PREVOST

WARRANTY BULLETIN

WB14-32

DATE :	SEPTEMBER 2014	SECTION: 06- Electrical
EXPIRATION:	SEPTEMBER 2016	
SUBJECT :	MASTER RELAY CORROSION

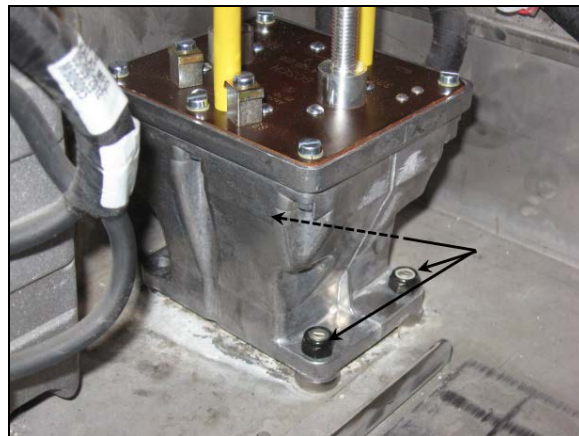
12. With the help of an assistant, install the three (3) new 30mm bolts from under the vehicle and slide the six (6) stainless flat washers over the bolts threads in the battery box.

13. Remove the cover from the new relay and install the relay over the stainless washers. Hand tight the three (3) provided hex nuts.

14. Tighten the three (3) hex nuts to 16 ft-lb (22 Nm).

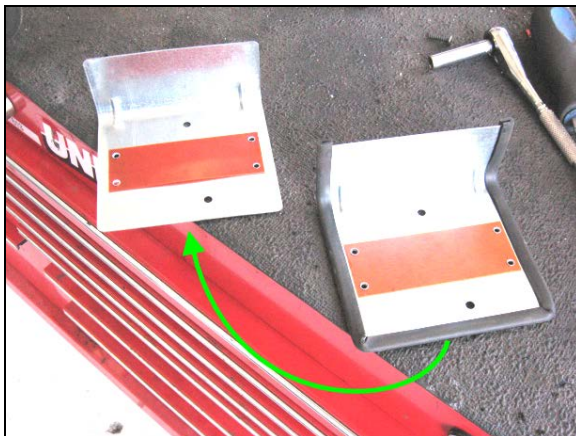
17. Remove the old relay cover trim, clean and put back on the new relay cover using fast drying adhesive (Loctite 404 or equivalent).

If the cover trim shows signs of deterioration or cannot be cleaned to allow correct adhesion, use 48cm (18in) of #56338 rubber trim to make a replacement.

The rubber trim is used on the relay cover to protect the surrounding wires and cable from abrasion against the cover sharp edges, Installation of the trim on the new cover is not an optional step.
